## VOICE CONNECTING ARRANGEMENT RCZ CONNECTING ARRANGEMENTS RTT AND RC1 AND 4-WIRE SERVICE KS-19645 TYPE RECORDER CONNECTOR

1.001 This addendum supplements Section 463-340-120, Issue 4.

1.002 This addendum is issued for the following reasons:

Fig. 29—KS-19645, List 6 Recorder Connector

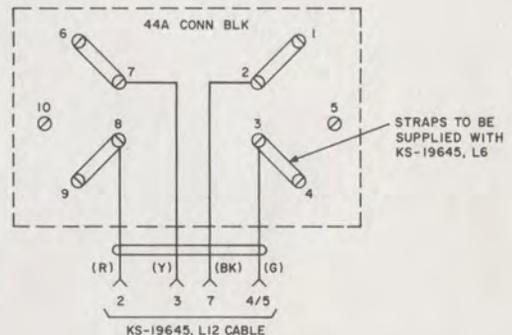
2.003 On page 7, following KS-19645, List 11 Network (Fig. 4), add:

#### *KS-19645, List 6 Recorder Connector*

- The KS-19645, List 12 cable has been developed for use with the KS-19645, List 2 recorder connector to allow the customer to terminate his interface leads on screw terminals rather than on the Cannon plug. See Fig. 29.

2.004 On page 14, at the end of the Connection Index listing, add: Fig. 29—KS-19645, List 6 Recorder Connector.
